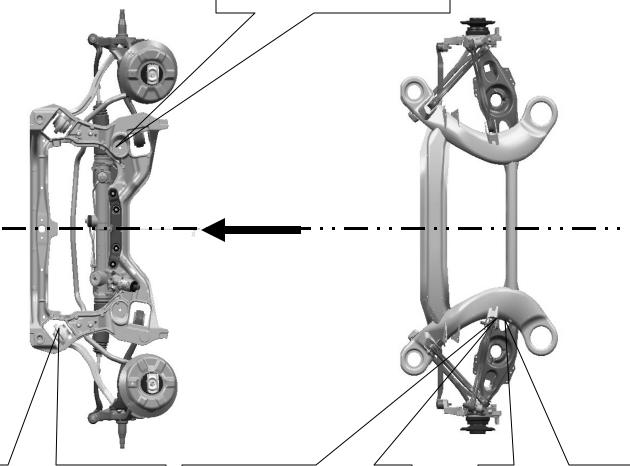
Previously: 15.5 New: 14.5

Modified torque strut mount

470 N/mm (-22%)
Previously: 600N/mm

Rear spring/damping

Rear torsion bar 1 mm thicker

Previously W203: 13mm

New W203: 14mm

Spring link mount

11 kN/mm (- 56%) Previously: 25kN/mm
